# UNITED STATES PATENT AND TRADEMARK OFFICE

APPLICATION NO.	FILING DATE	FIRST NAMED INVENTOR	ATTORNEY DOCKET NO.	CONFIRMATION NO.
10/617,026	07/11/2003	Seung-Woo Lee	6192.0302.US	2713

<b>Office Action Summary</b>	<b>Application No.</b>	<b>Applicant(s)</b>	
	10/617,026	LEE ET AL.	
	<b>Examiner</b>	<b>Art Unit</b>	
	Seokyun Moon	2629

## DETAILED ACTION

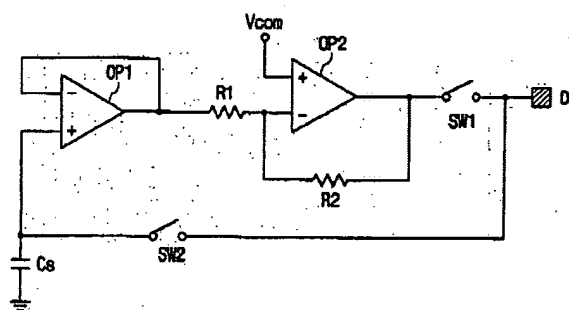
As to **claim 4**, Kim modified by Lien teaches the slave driver comprising:

a storage (Lien: "*full frame buffer*") [Lien: fig. 3] for storing the data voltages applied to the data line in the second period; and

an inverter (Lien: "*inverter 6*") [Lien: fig. 3] for inverting the polarity of the data voltages stored in the storage [Lien: fig. 2f], the storage and the inverter alternately connected to the data line (Lien: "*analog toggle 4*" alternately connects the storage and the inverter to the data lines) [Lien: col. 5 lines 40-49].

Drawing 1

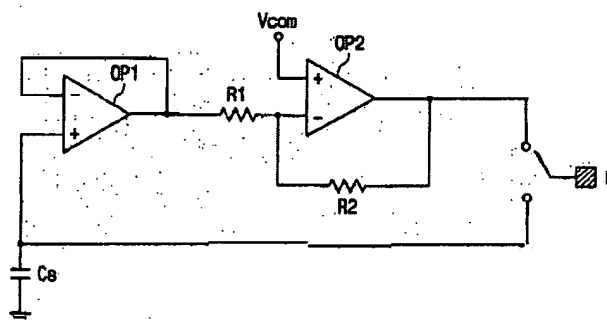
However, since the Applicants have failed to disclose that including two switches in the switch unit provides an advantage, is used for particular purpose, or solves a state problem, it is an obvious matter of design choice to include two switches in the switching unit.

Therefore, it would have been obvious to one of ordinary skill in the art at the time of the invention to use a toggle switch for the switching operation of the driver, since a toggle switch would perform equally well at selectively connecting inputs from the storage and the inverter to the data line. Drawing 1 is provided below to illustrate an alternative design/structure for the switching unit.
